## Broadcast Products Technical Bulletin 20-2011-087

SUBJECT: **INCORRECT PART NUMBER PRINTED ON  
CN-2437 BOARD**

MODEL: **DSR-400K**  
**DSR-400L**  
**DSR-400PK**  
**DSR-400PL**  
**DSR-450WSL**  
**DSR-450WSPL**  
*DSR-600PL*  
*DSR-650WSPL*  
**DVW-970**  
**DVW-970P**  
*MSW-930P*  
**MSW-970**  
**MSW-970P**  
**PDW-510**  
**PDW-510P**  
*PDW-510P//U*  
**PDW-530**  
**PDW-530P**  
*PDW-530P//U*

**Figure 1**

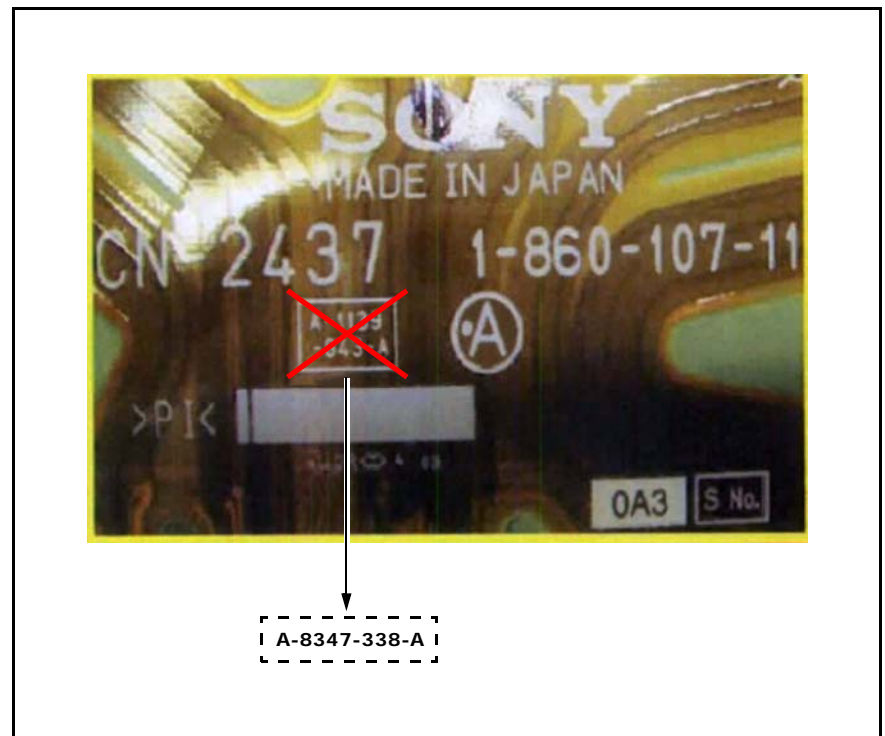
An incorrect part number may be printed on some CN-2437 boards. Correct the part number as follows and as shown in Figure 1.

Incorrect	Correct
A-1139-843-A	→ A-8347-338-A

**NOTE:** The correct part number printing combination is:

A-8347-338-A ↔ 1-860-107-11
